SERIAL NUMBER	FILING DATE	FIRST NAMED APPLICANT	ATTORNEY DOCKET NO.
07/041,994	04/24/87	EKLUND	615-020-011

EXAMINER'S ACTION

For: HIGH VOLTAGE MOS TRANSISTORS

AMENDMENT

Fig-5

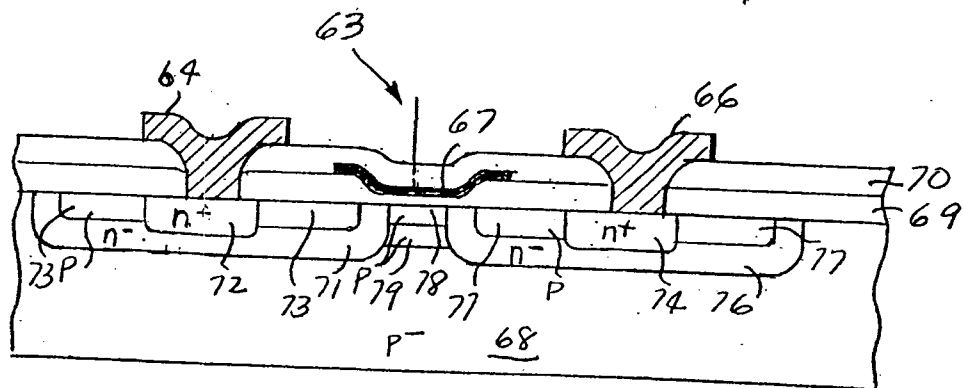
Claim 23 is directed to the transistor, shown in Fig. 5 of the drawings, that has been modified for source-follower applications by providing both extended source and drain regions. Top layers cover intermediate portions of the extended source and drain regions. The top layers and substrate are subject to application of a reverse-bias voltage.
